Automobiles S.p.A.
Quality - P.S. & Safety
C.so Agnelli 220
10135 Turin

P. 265/07

Job Nr. 5180 – 5181 – 5182 – 5183 – 5184 - 5185
Model Fiat BRAVO
- VARIOUS INTERVENTIONS

RECALL CAMPAIGN - 5180

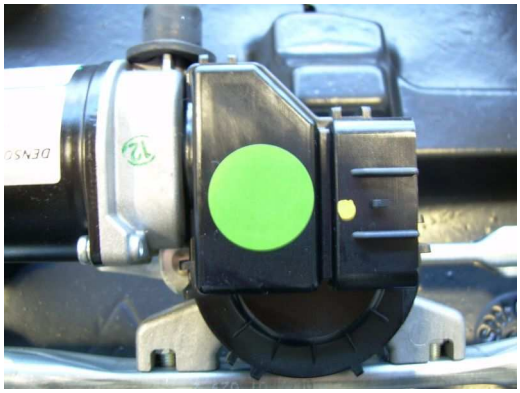
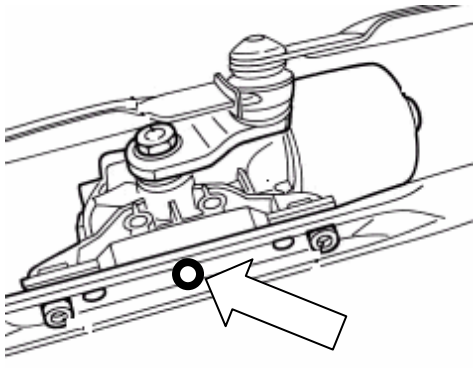
Check if there is a GREEN label applied on the lid of the geared motor.

- Look through the grille on the bottom side of the windshield and check if the GREEN label applied on the lid of the geared motor.

- Replace the windshield wiper unit with **part. 51757840** as described on instruction 5050B38

- Replace screws/washers that fix the windshield base lining with **part. 51805248**, tighten to **4 Nm.**

SERVICE CAMPAIGN - 5184

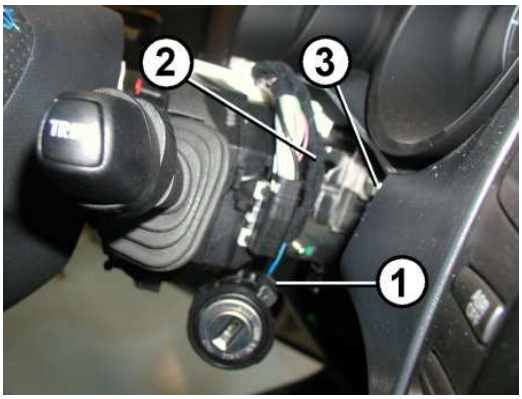
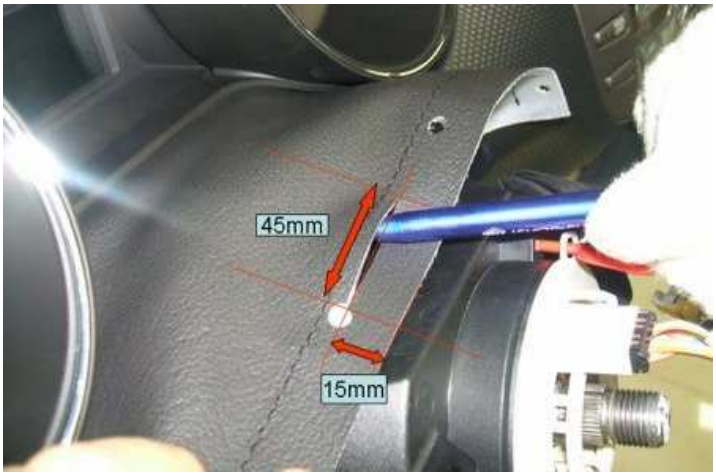
Check proper positioning of the immobilizer antenna cable on the power steering, then see that the Air bag cable is whole and anchor the column covering curtain to the clip located on the upper part of the column as follows:

- Disassemble lining of the steering column as descried on instruction **7040A26**)
- check proper connection of immobiliser cable to antenna **1** then check that cable **2** does not interfere with the fixing nut of the steering column lever **3**; position antenna cable **2** as shown in the figure

- Check proper arrangement of the Air-Bag cables (arrow).

- Reposition Air-Bag and Immobilizer cabling

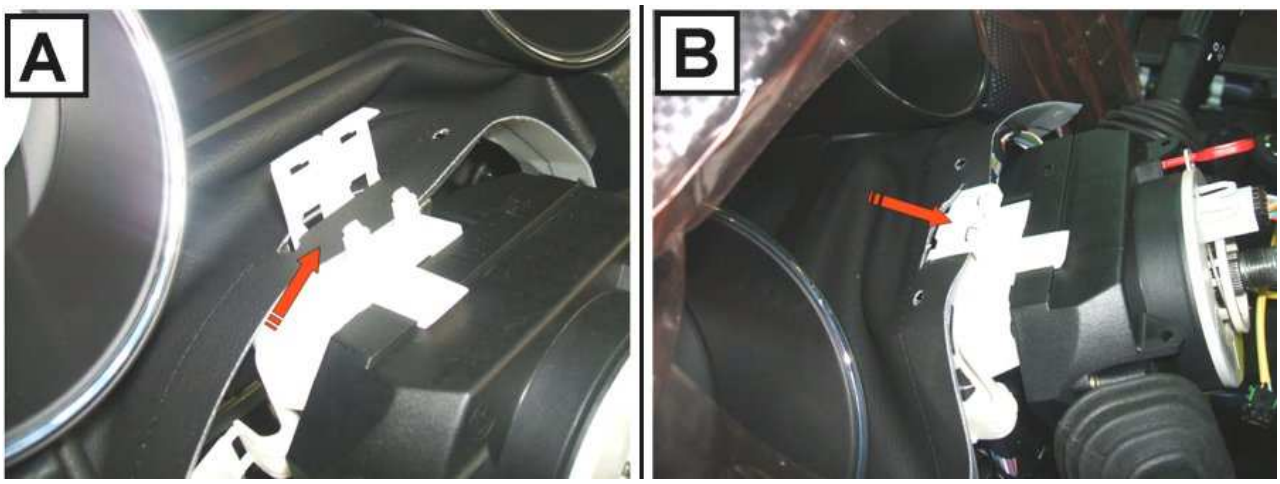
Anchor the steering column curtain to the clip located on the upper part of the column and make a cut with the cutter (45 mm long starting from the existing slot) at 15 mm from the edge of the curtain cover as shown in the figure.

- Open the clip **(arrow Fig. A)** insert it in the steering column curtain cut made previously.
- Close the clip **(arrow Fig. B)** to assure anchorage.
- Reassemble steering column lining carrying out disassembly instructions vice versa
